## MEQI-63 Series and Accessories LC

## Design Change Notification

## MEQI-63 Series

**BC**  
馬達直結

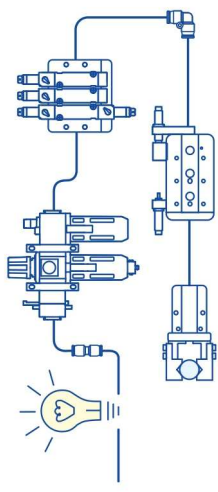
Design optimization. Unify all product lengths with different BC motor types. Unify LC accessory construction.

代號 規格	A	B1	B2	C	E	G	H	I	J	K	L1	L2	O	R	S	X	Y	ZB	ZC	ZT
63	32	17	24	37	M16×1.5	30	45	19	4	35	4.5	18	56.5	8	M8×1.25	77	77	162	64.0	263.0

**LC**

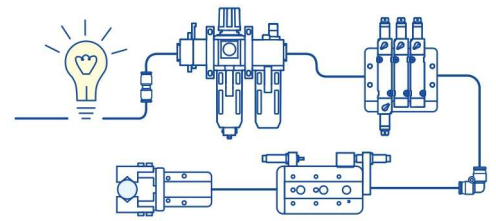
- It will not affect the usage of finished product, and will replace sequentially.
- Accessories **LC** will be replaced with new construction from now on.

代號 規格	A	E	LB	LH	LR	LS	LT	LX	LY	ZT
63	32	M16×1.5	9	50	92	110	12.5	88.5	176.5	231
